CITY OF MADISON

PLAN OF PROPOSED IMPROVEMENT

CITY PROJECT NO. 14582
CONTRACT NO. 9302

5604 SCHROEDER ROAD

PLAN & PROFILE - SCHROEDER RD
 5604 SCHROEDER ROAD
 M:\DESIGN\Projects\14582\CAD\Streets\14582EN-PnP.dwg

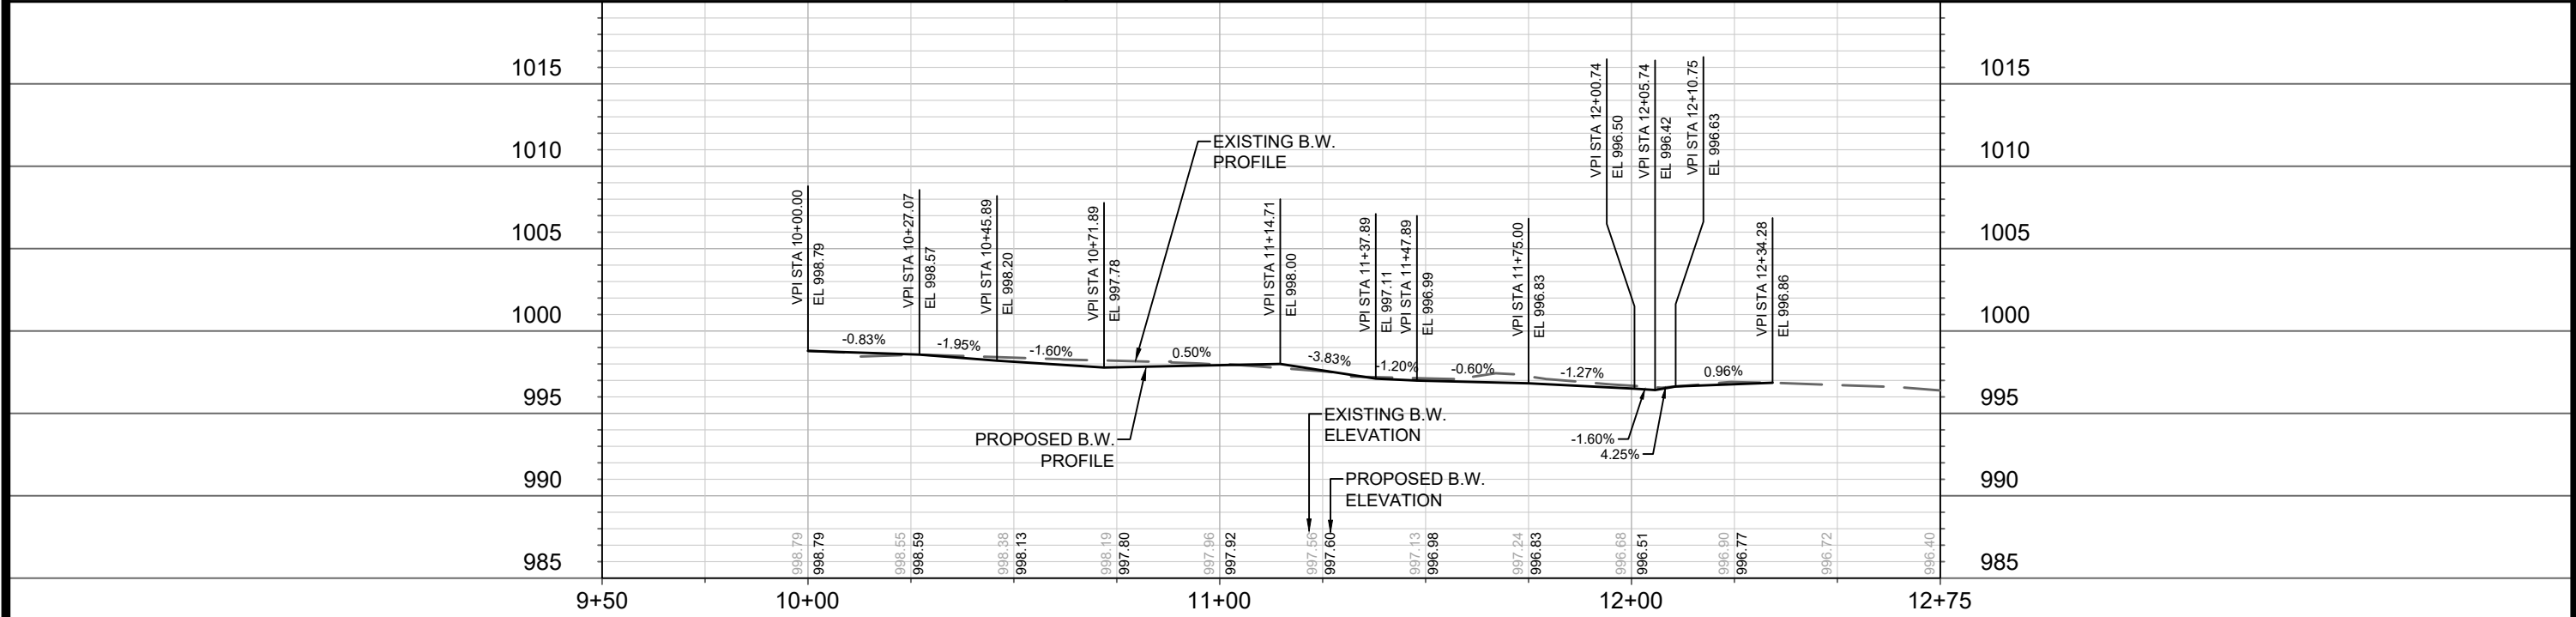
REVISION: 07/27/2023
 1. REVISED TO SHOW UPDATES TO WATER LATERAL SHOWN ON SHEET U-1
 2. ADJUST PAVEMENT PATCHING AREA TO CHANGES ACCORDINGLY

UTILITY PLAN & PROFILE - SCHROEDER RD
5604 SCHROEDER ROAD

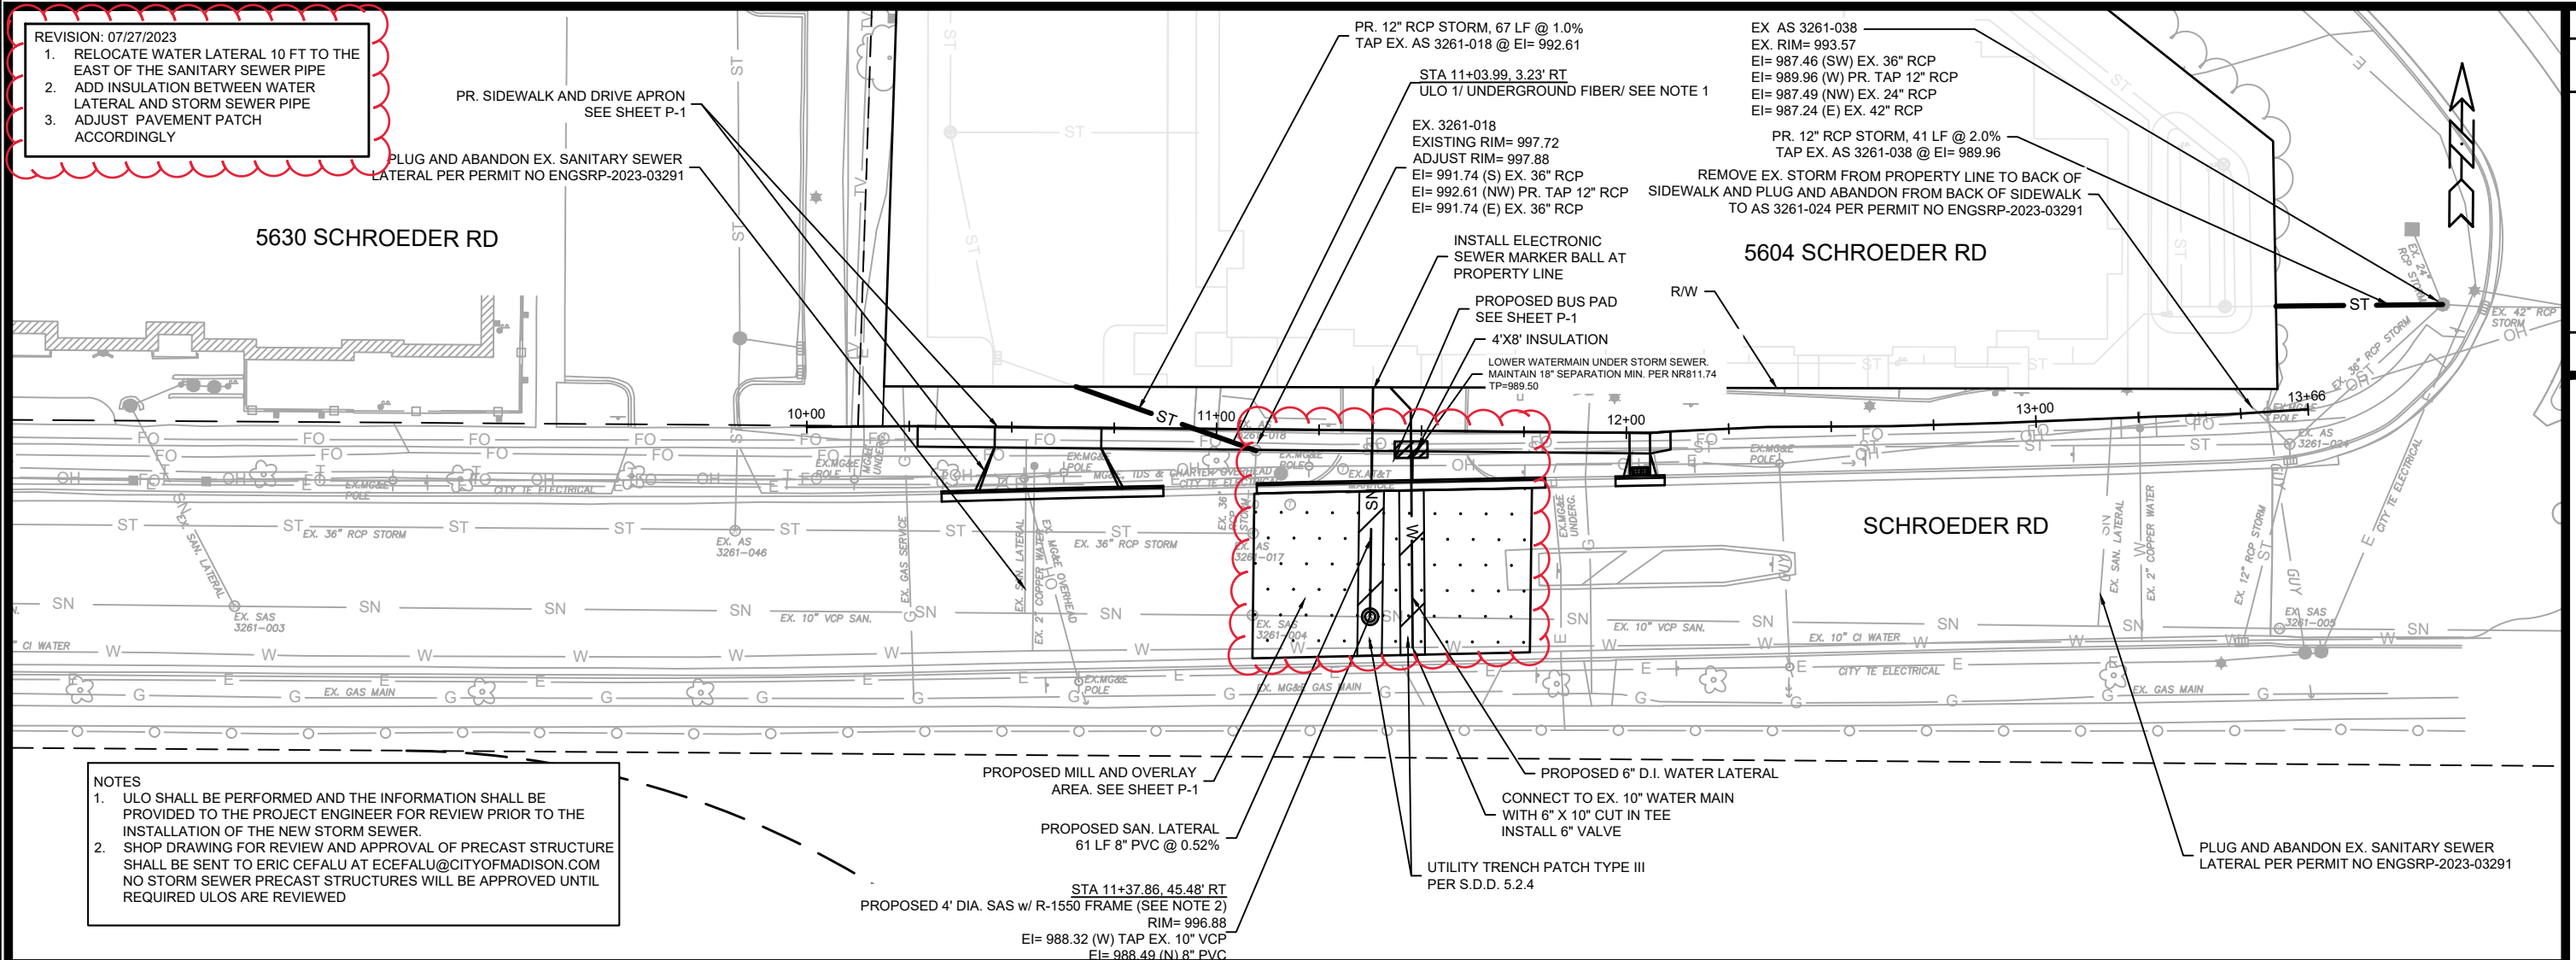
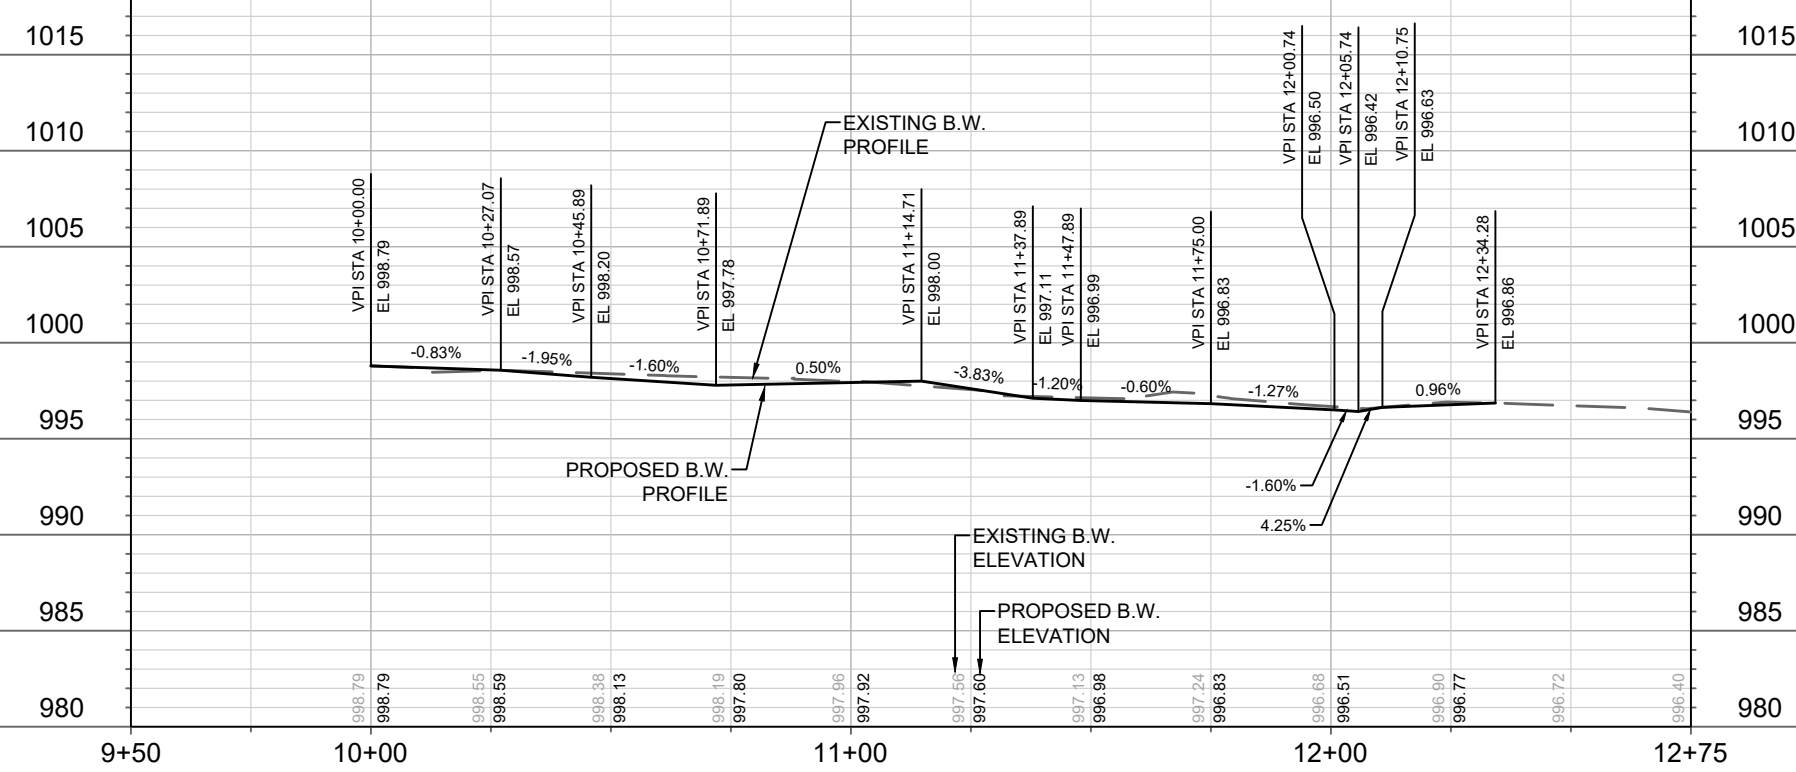
- REVISION: 07/27/2023
1. RELOCATE WATER LATERAL 10 FT TO THE EAST OF THE SANITARY SEWER PIPE
 2. ADD INSULATION BETWEEN WATER LATERAL AND STORM SEWER PIPE
 3. ADJUST PAVEMENT PATCH ACCORDINGLY
